Fancy Fashion Sweaters Ltd.

1153-54, Shahid Siddique Road, Khailkur, Board Bazar, Gazipur-1704, Bangladesh
(23.942443N, 90.388539E)

23 March 2014

Observations

Loading from water tanks

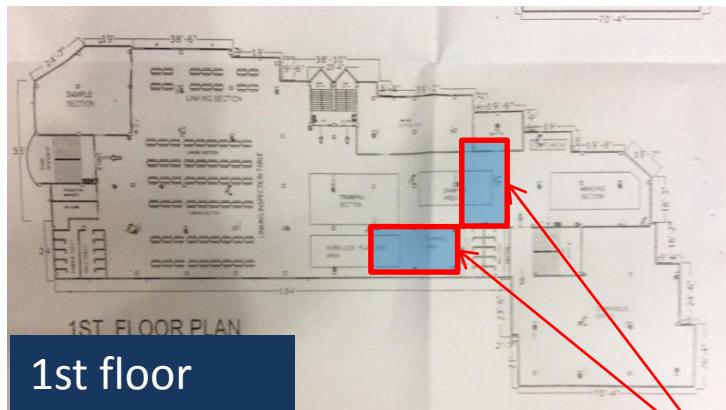
Concentrated high loading from water tanks on roof slab

Four 5000 litres water tanks mounted on flat concrete plinth on flat slab close to columns. Tenant confirmed only half full with valve to electrically control.

Building Engineer to check that slab has been designed to accommodate loads in flexure and punching shear.

15	Concentrated high loading from water tanks on roof slab	Building engineer to check the slab for punching shear and flexural strength.	6-weeks
16	Service hole close to column locations	Building engineer to check the slab for punching shear. Holes sides to be made good. Exposed reinforcement to be cleaned of all rust and holes sides to be formed providing adequate cover to the reinforcement.	6-months

Loading in uncontrolled areas

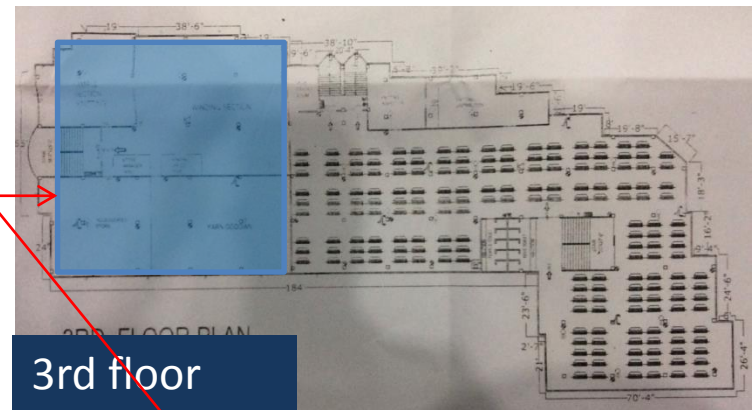
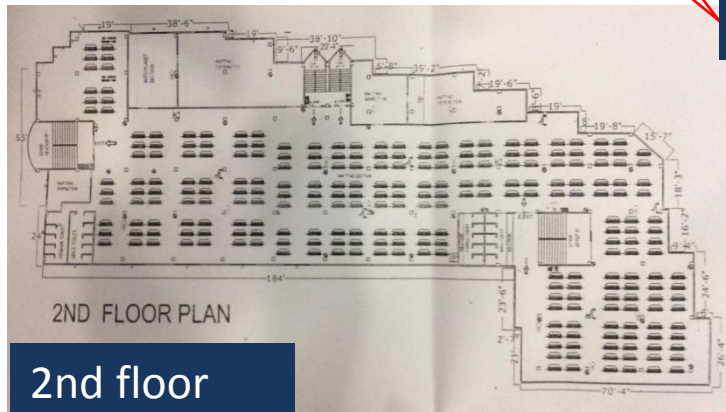
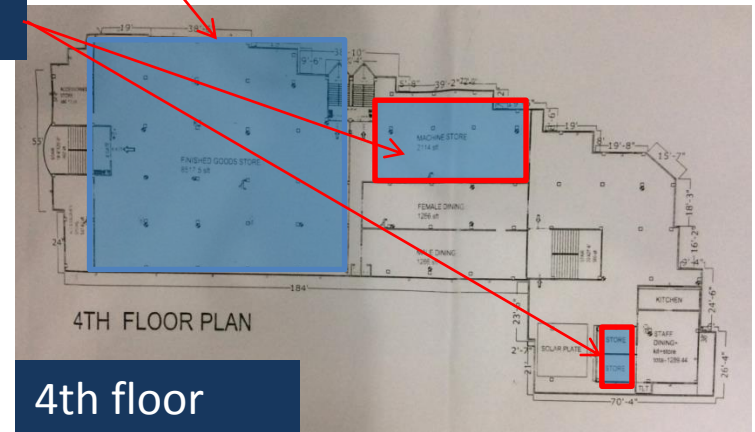
1st floor

Controlled

3rd floor

Uncontrolled

2nd floor

4th floor

Material stacked within storage areas and other areas.

Plan and height restrictions to be introduced to currently uncontrolled areas, to prevent future overloading.

In area labelled uncontrolled loading should be limited in accordance with loading plans until DEA complete and results available.

Movement joint

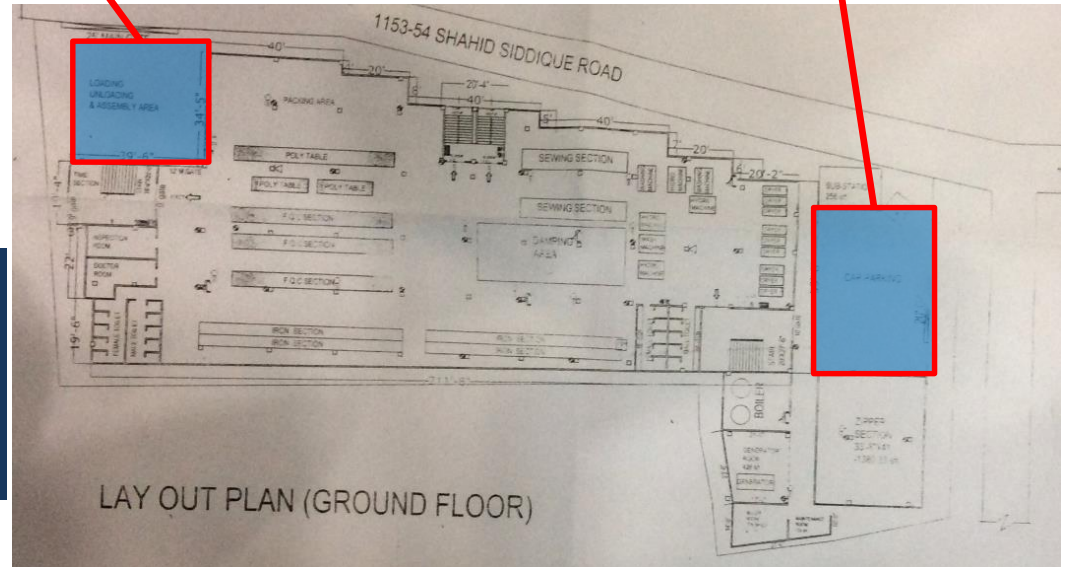
Movement joint repair required to maintain durability of concrete and prevent plaster falling from height.

Vehicle Impact on Ground floor columns

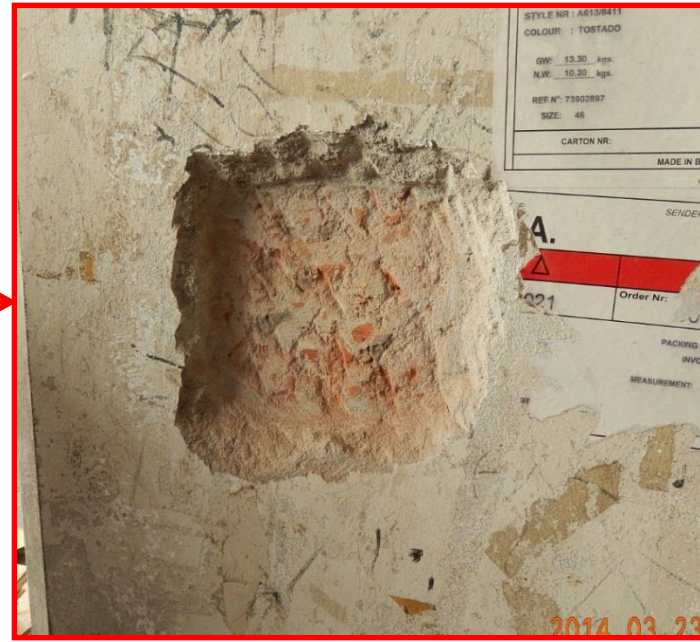
**Column at ground floor should be
protected from vehicle impact in the
loading bay**

Large cantilever at corner of building. Engineer to justify in the Detailed Engineering Assessment

Loading bay and parking area columns to be protected for vehicle impact or strengthen for vehicle impact load
